To : **Bina Puri – Zublin JV**
Attn : **Mr John Hendriks**
From : **Lee Kian An / Lee Hong Cheong**
Date : **10 April 2006**
Ref : **1041C/2512M/06**
Sub : **Capital Square – Condominium 1**
Re : **Building Settlement Monitoring Report**
Cc : a) Capital Square Sdn Bhd – Mr Chan Boon Li
b) GDP Architects Sdn Bhd – En Mohd Haziph Ahmad
c) Consultant Site Office – Mr W W Choo / Mr Tan Kian Wah
Pages : **5 [including this page]**

Our comments on the building settlement monitoring report for 10 February 2006 to 10 March 2006 are as follows :

Building Settlement Report (10 Feb 2006 to 10 Mar 2006)

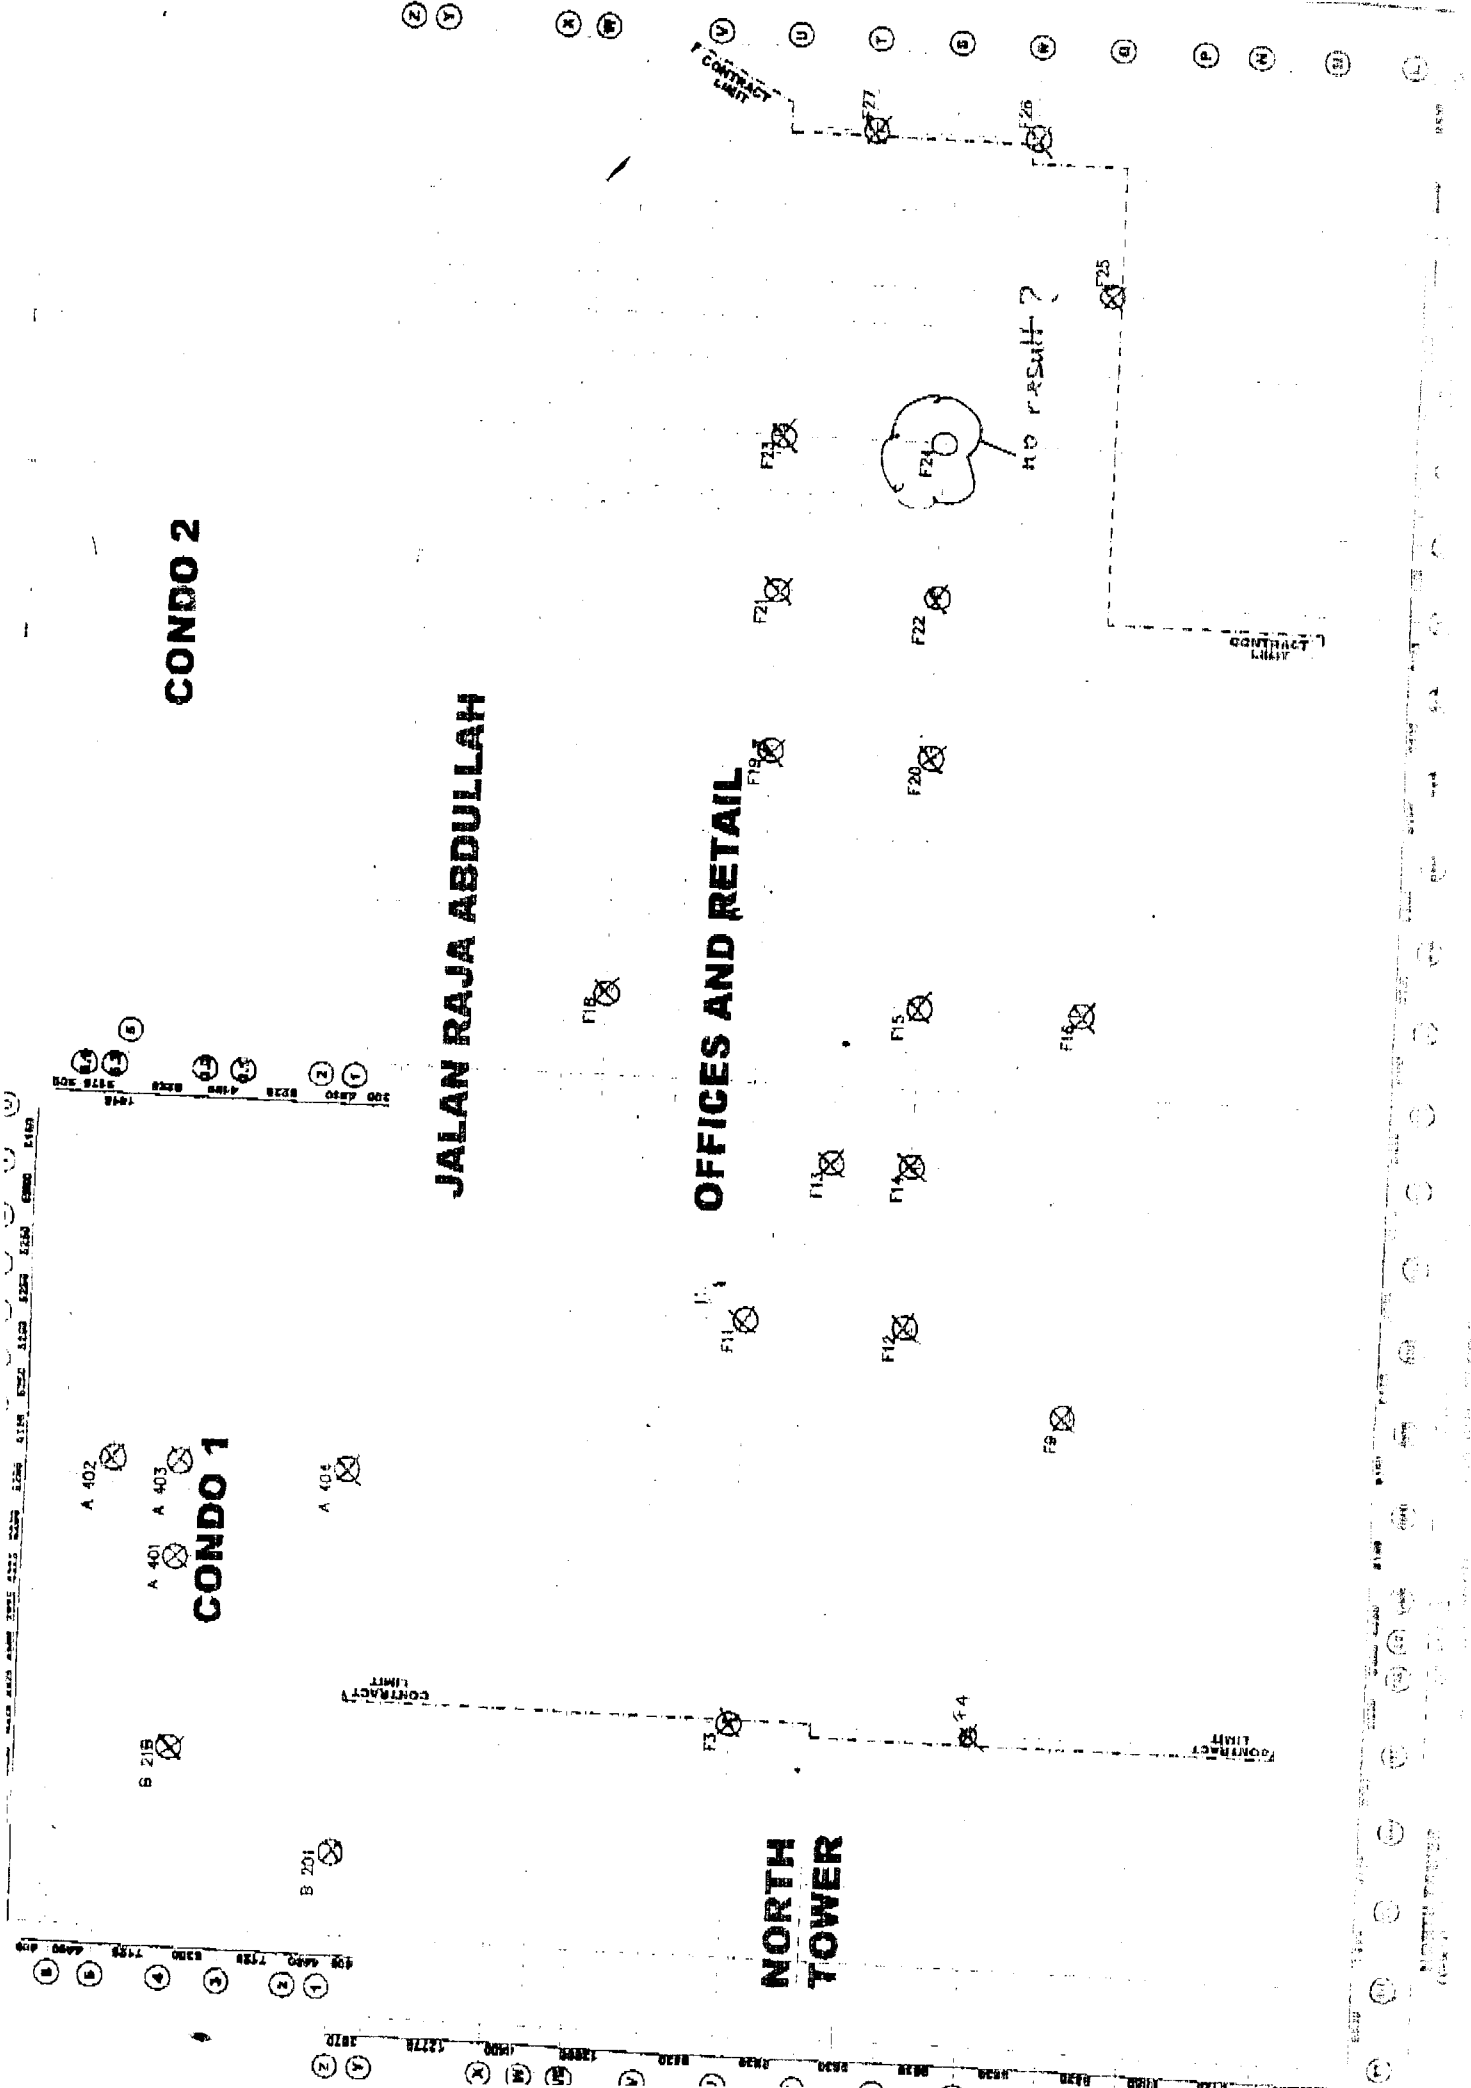
1. There is no reading for point F24. Points A1 to A7, A9, B1 to B5, B7 to B8, B10 to B15, B18, B20, CP6, CPF, CP201, 503 to 504, CP206, B208 to E209 have readings but not shown on plan.

3. For points CP201, 503 to 504, CP206, F15 to F16, F18 to F23, F25 and F27 to F28, the settlements are approximately -5mm (downward) for the month of January 2005 to February 2006 but become approximately +5mm (upward) for the month of February 2006 to March 2006. We doubt the reliability of the readings. Please confirm.

Please
check
again
